From: McLain, Joy [Joy.McLain@tetrattech.com]
Sent: Monday, October 10, 2011 7:36 AM
To: blm@gwcomment.com
Subject: FW: TNC request for additional public comment -- Gateway West
Attachments: Simpson Letter -- Gateway West.pdf

Re: Gateway West Transmission Line – Request for Additional Public Comment

The Snake River Alliance (“Alliance”) appreciates the opportunity to provide comments relating to the Bureau of Land Management’s draft environmental impact statement (DEIS) for the Gateway West Transmission Line Project.

Figure 2. Proposed Gateway West corridor alternatives and results of the development suitability assessment.

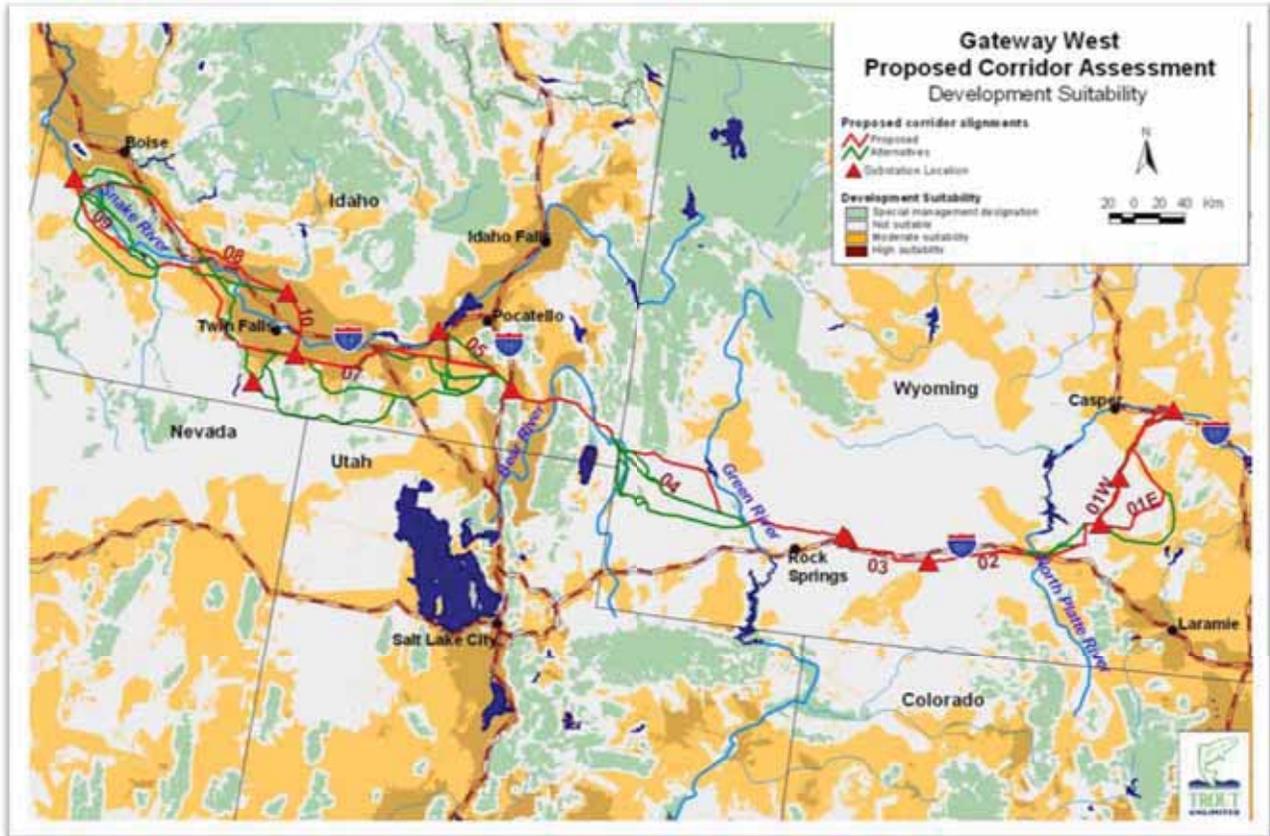
Figure 2 below depicts the proposed corridor alternatives under consideration in conjunction with results of the development suitability assessment from the Renewable Report. By integrating results of the human footprint analysis with native trout distributions and core sage-grouse habitat, the suitability assessment provides a way to quickly identify some of the proposed corridors that are the most problematic. The first four sections (01W, 01E, 02, 03, and 04) are all associated with landscapes identified in our assessment as not suitable for development often due to the presence of special management areas (e.g. roadless area, wilderness study area, state or federal park), sage grouse core areas or significant coldwater habitat.

Figure 3. Results of human footprint assessment and alternatives for Sections 01W, 01E, 02, and 03.

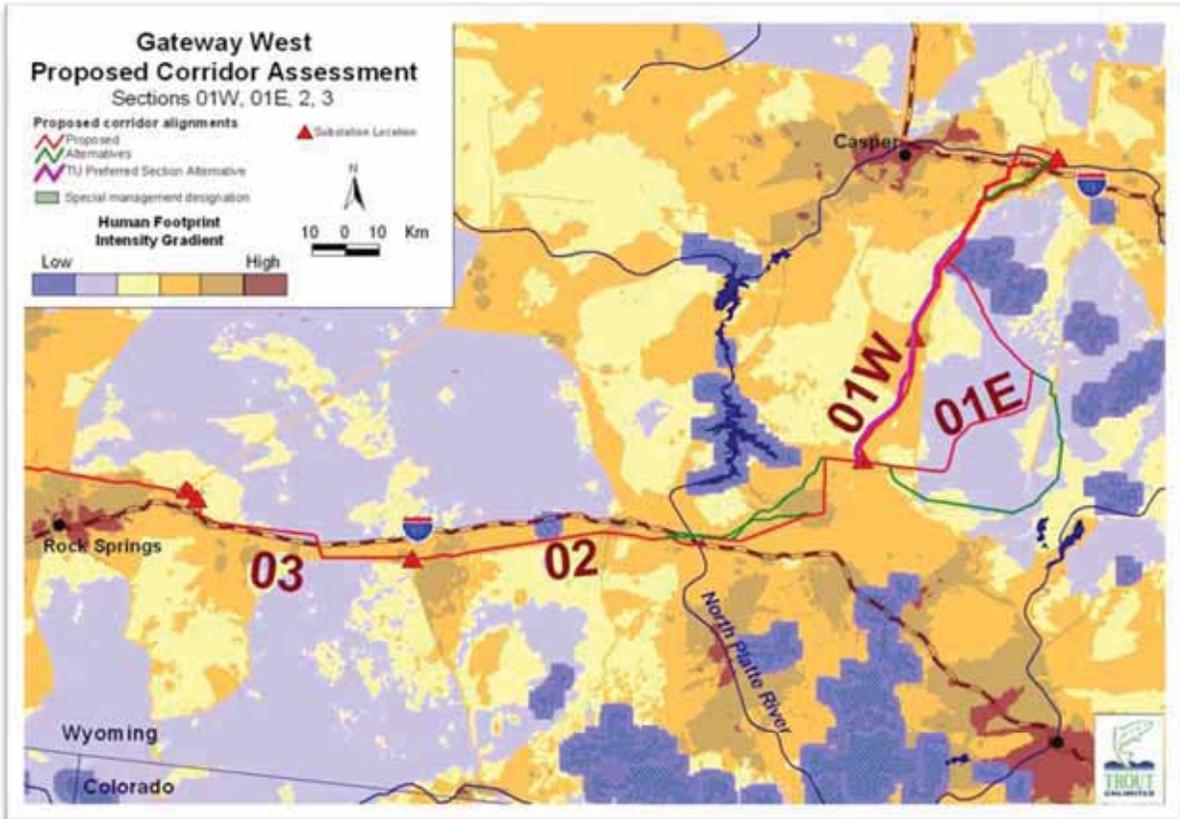
Using the results of the human footprint assessment as an indicator for habitat integrity it is evident that much of the transmission line in sections 02 and 03 is associated with low quality habitat as a result of generally following the Interstate 80 highway corridor. Site specific assessments associated with the North Platte River and its tributaries will be required to determine the preferred location of roads and towers in order to minimize sediment delivery into this important coldwater habitat. As Figure 3 shows, section 01E is problematic at the landscape scale as both TU's preferred alternative and alternative 01E-B (not shown but located south of 01E as the green line) cross a landscape that is at the lower end of the spectrum for human disturbance. Alternatives 01E-C and 01W parallel each other and are associated with more degraded landscape as well as an existing transmission line thus minimizing additional habitat fragmentation. Therefore, that alternative is shown in purple (01W) on the map as TU's preferred alternative for this section of the transmission system.

Figure 4. Results of human footprint assessment and alternatives for Section 04.

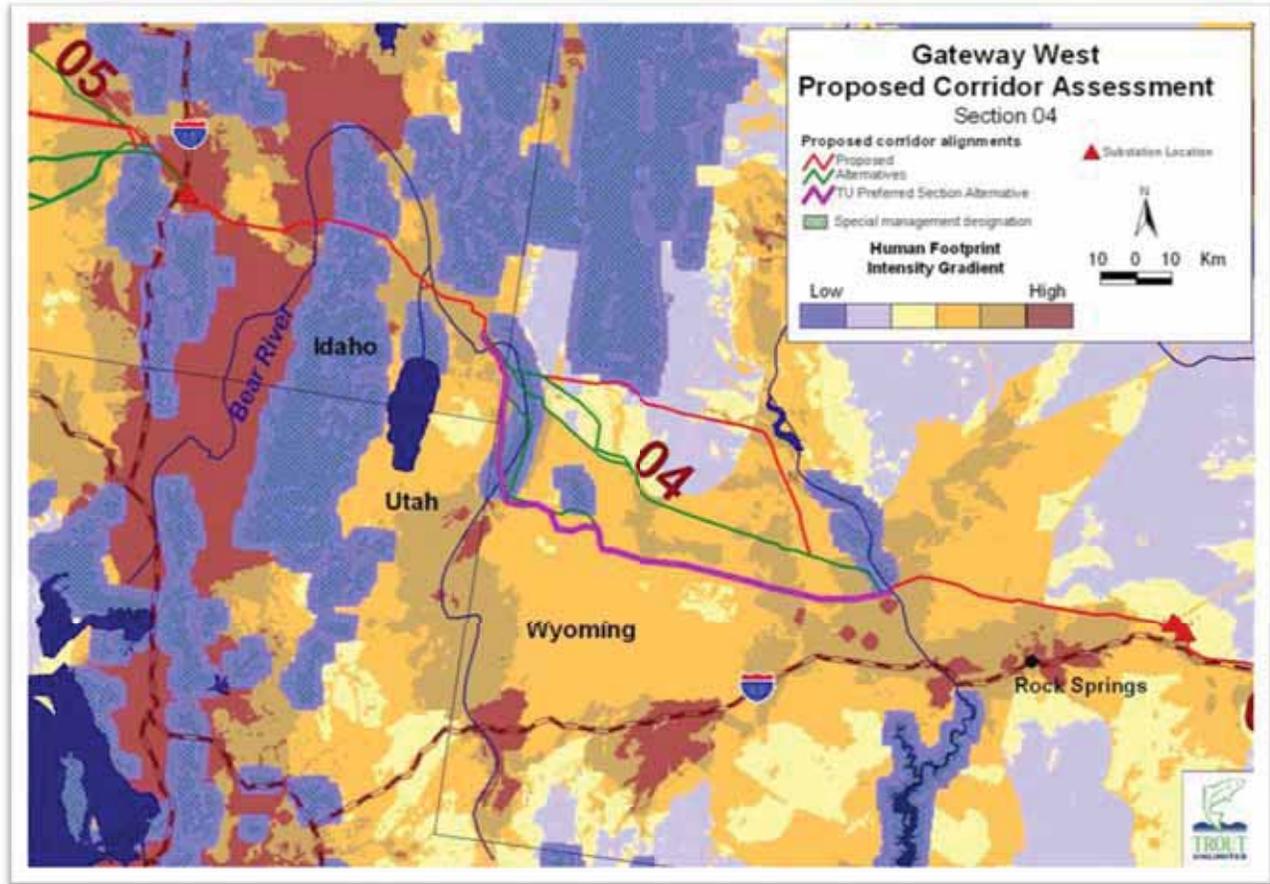
Figure 4 shows the results of the human footprint analysis in conjunction with section 04 of the transmission system. The proposed alternative bisects an area that likely provides moderate to high habitat quality in an area designated as a sage-grouse core area. Although alternative 4B-C, TU's preferred alternative, also crosses the sage-grouse core area, it is associated with lower quality habitat and existing corridors so there will be less additional habitat fragmentation. These southern most alternative sections follow existing corridors, highways and railways. From the juncture of alternative 4B-C, we would then support the alternative section that becomes section 4E which follows Wyoming Highway 30.

We would recommend against alternative 4B-D as it follows the most western Wyoming border route, intersecting portions of the Cokeville Meadows National Wildlife Refuge. The Refuge supports one of the highest densities of nesting waterfowl habitat in Wyoming, has potential for the reintroduction of trumpeter swans, and provides significant and important habitat for greater sage grouse, mule deer, elk and pronghorn. In addition, TU has several Bonneville cutthroat trout habitat restoration projects established near the Refuge boundaries and numerous drainages within the Refuge.

Figure 5. Results of human footprint assessment and alternatives for Section 07, 08, 09, and 10.

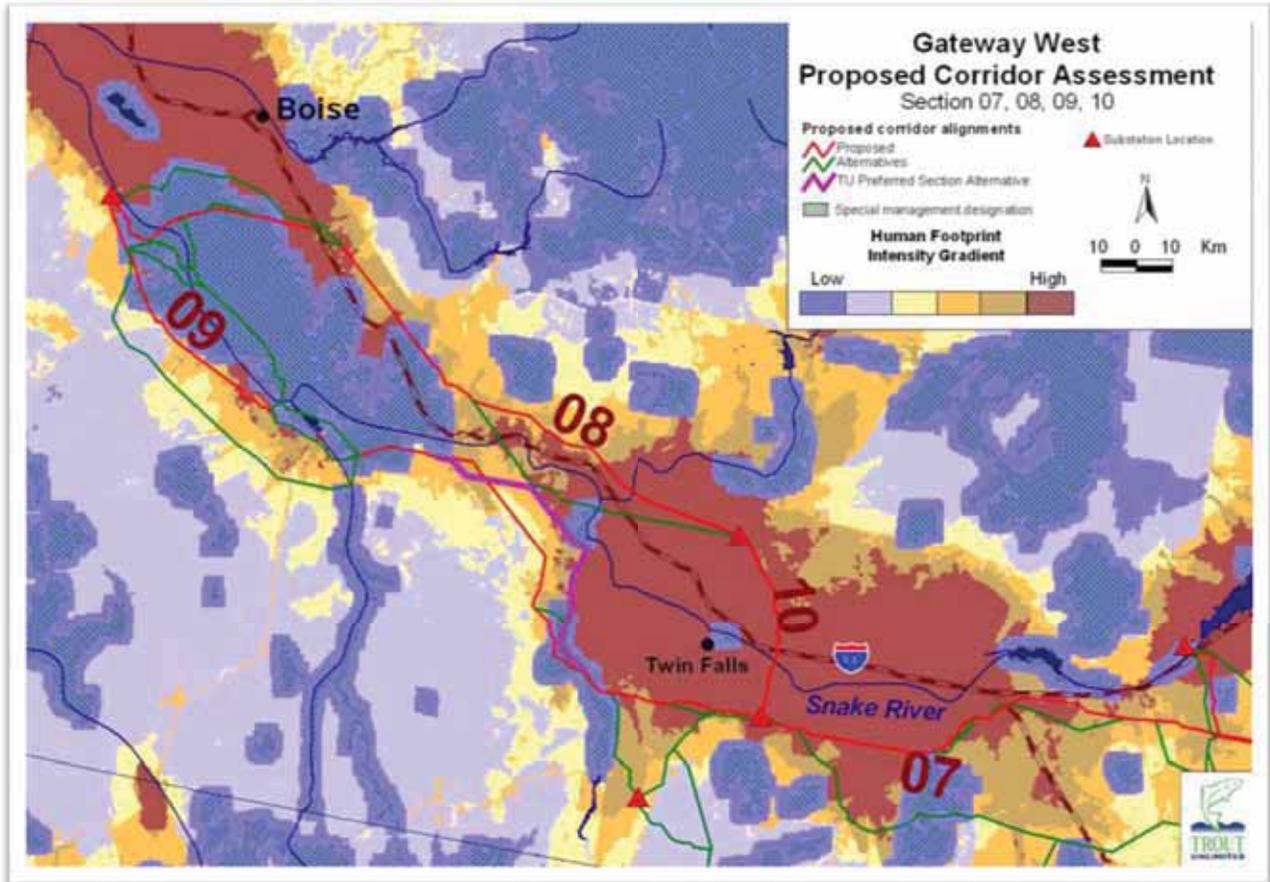
Figure 5 shows the alternative alignments for sections 07, 08, 09, and 10. In general, TU's preferred alternative is associated with degraded and converted lands so additional habitat fragmentation is less of a concern. Stream crossings or any construction within or adjacent to the riparian area will require site specific analyses to minimize impacts to aquatic resources. Section 09 crosses a number of special management areas including the Snake River Birds of Prey Area and the Salmon Falls Creek Wild and Scenic River. In order to minimize impacts to these important resources we recommend the use of existing transmission corridors and rights-of-way whenever possible. We also prefer stronger buffer setbacks to minimize the potential for soil erosion and damaging sedimentation to important native trout habitat. For this reason, we prefer alternative 9B for section 09 since it parallels an existing transmission line and avoids crossing Salmon Falls Creek in either the eligible or designated wild and scenic river sections.

Figure 6. Native trout populations in Western Wyoming which may be potentially impacted by the Gateway West transmission project.

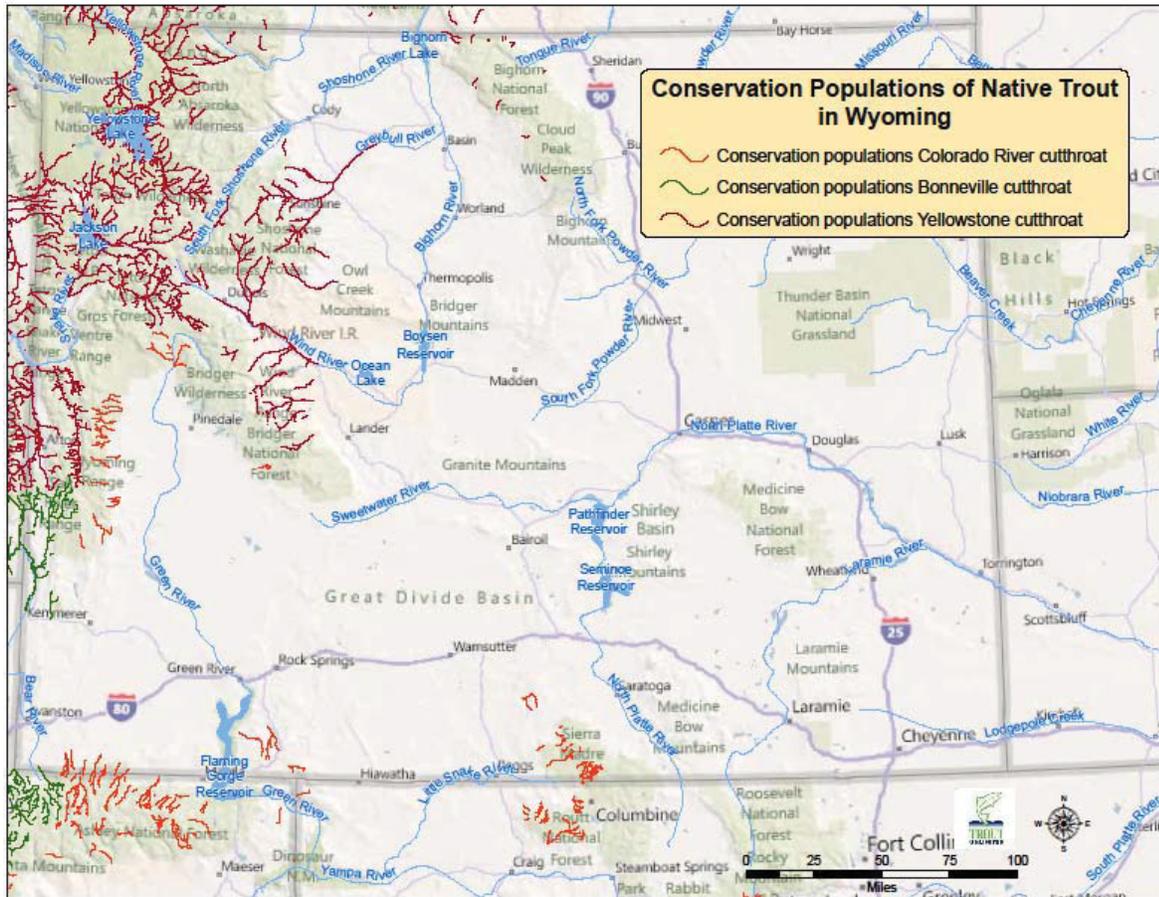
improvement efforts. As illustrated in Figures 6 and 7, native trout habitat exists in several areas in Wyoming and Idaho along the transmission route and it is our desire to maintain the integrity of these important ecological resources.

Figure 7. Native trout populations in Eastern Idaho which may be potentially impacted by the Gateway West transmission project.

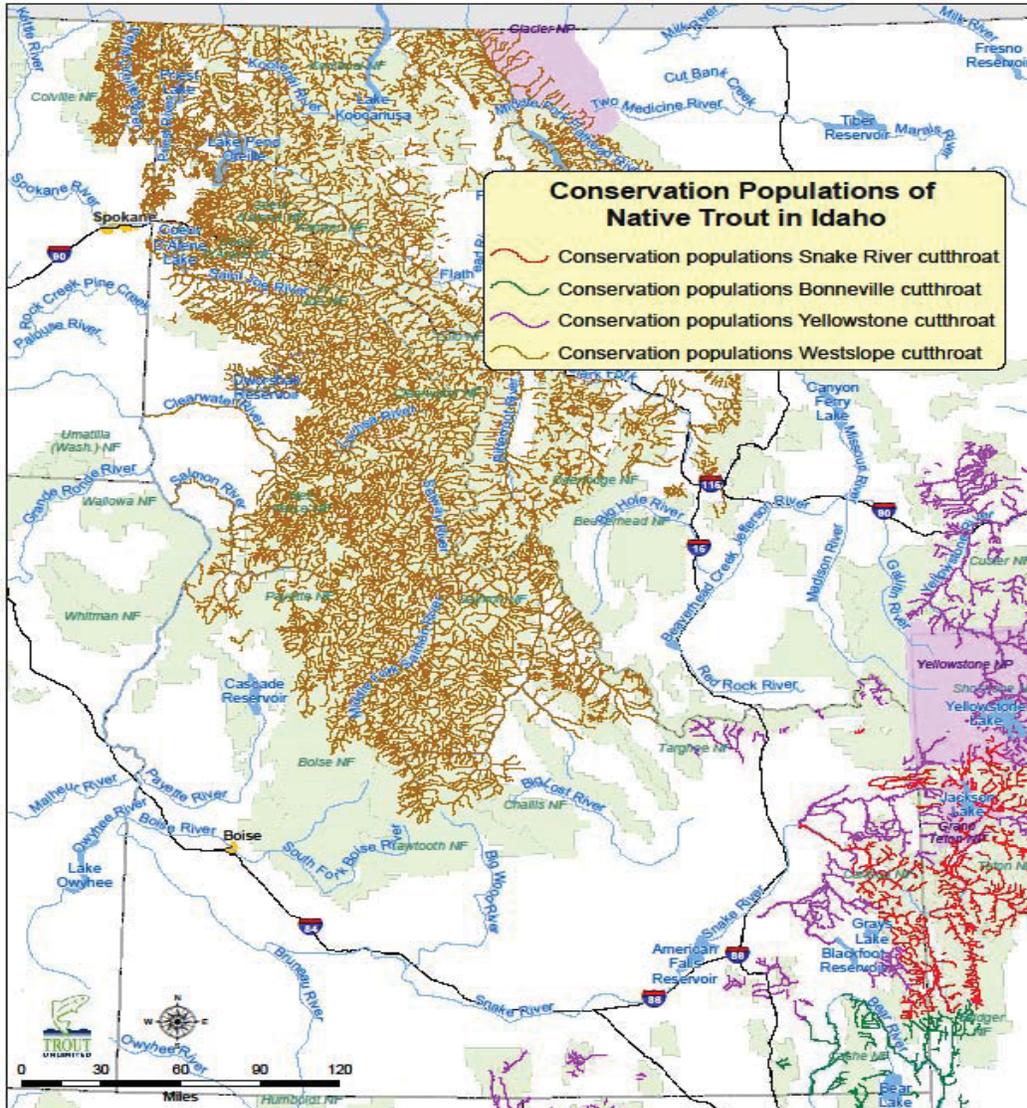
Westslope cutthroat (WCT) populations include habitat areas in Idaho and has been identified in the DEIS as a cutthroat species occurring within the project boundaries. However, the BLM may want to reassess this statement as most of the science and agency data shows its habitat range as further north (see Figure 7) from the proposed transmission corridor.

Figure 2. Proposed Gateway West corridor alternatives and results of the development suitability assessment.

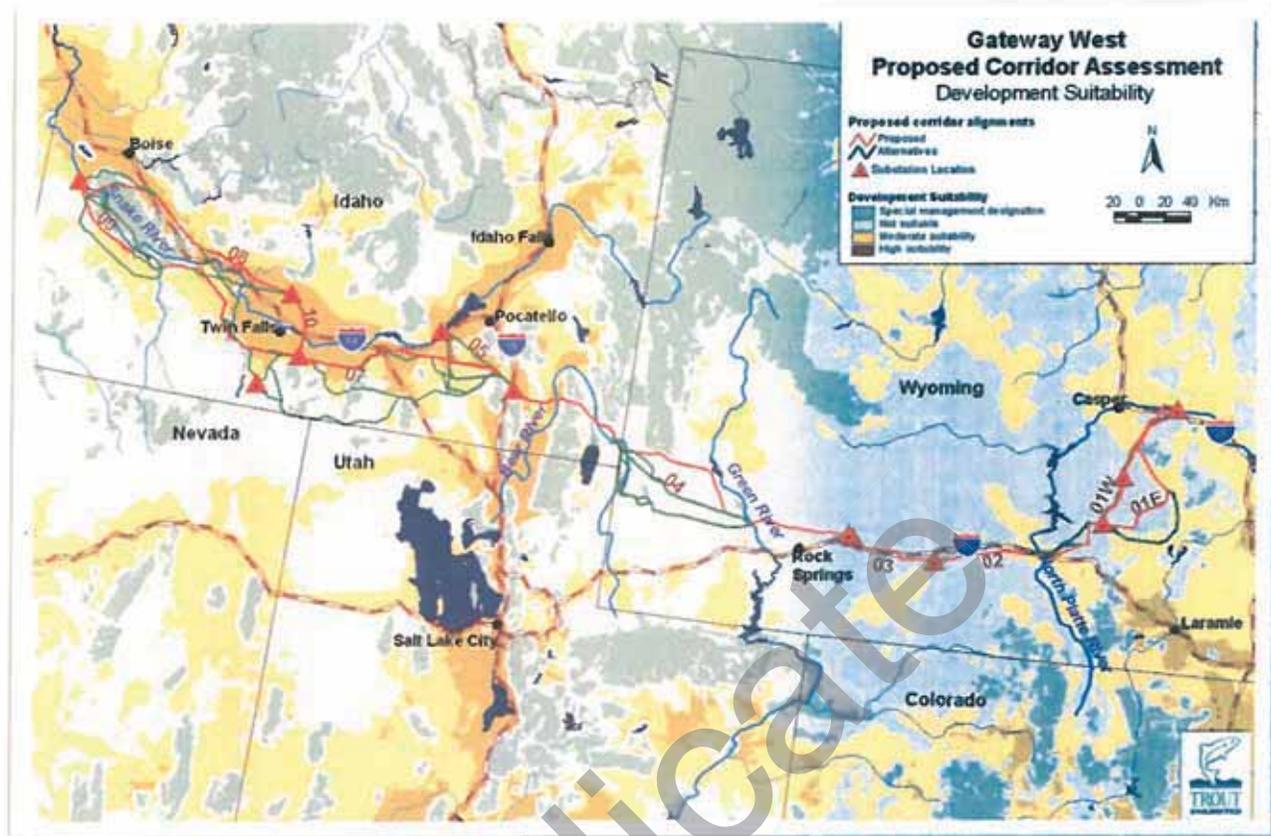
Figure 2 below depicts the proposed corridor alternatives under consideration in conjunction with results of the development suitability assessment from the Renewable Report. By integrating results of the human footprint analysis with native trout distributions and core sage-grouse habitat, the suitability assessment provides a way to quickly identify some of the proposed corridors that are the most problematic. The first four sections (01W, 01E, 02, 03, and 04) are all associated with landscapes identified in our assessment as not suitable for development often due to the presence of special management areas (e.g. roadless area, wilderness study area, state or federal park), sage grouse core areas or significant coldwater habitat.

Figure 3. Results of human footprint assessment and alternatives for Sections 01W, 01E, 02, and 03.

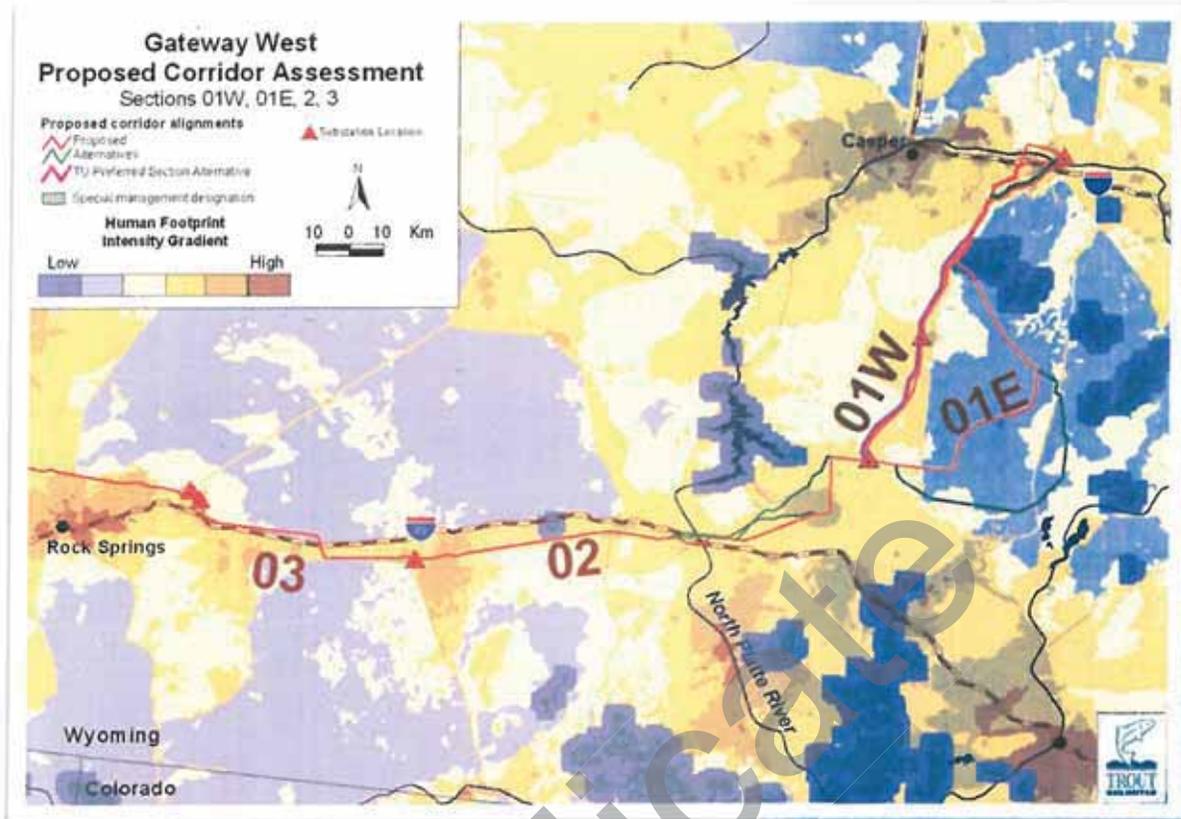
Using the results of the human footprint assessment as an indicator for habitat integrity it is evident that much of the transmission line in sections 02 and 03 is associated with low quality habitat as a result of generally following the Interstate 80 highway corridor. Site specific assessments associated with the North Platte River and its tributaries will be required to determine the preferred location of roads and towers in order to minimize sediment delivery into this important coldwater habitat. As Figure 3 shows, section 01E is problematic at the landscape scale as both TU's preferred alternative and alternative 01E-B (not shown but located south of 01E as the green line) cross a landscape that is at the lower end of the spectrum for human disturbance. Alternatives 01E-C and 01W parallel each other and are associated with more degraded landscape as well as an existing transmission line thus minimizing additional habitat fragmentation. Therefore, that alternative is shown in purple (01W) on the map as TU's preferred alternative for this section of the transmission system.
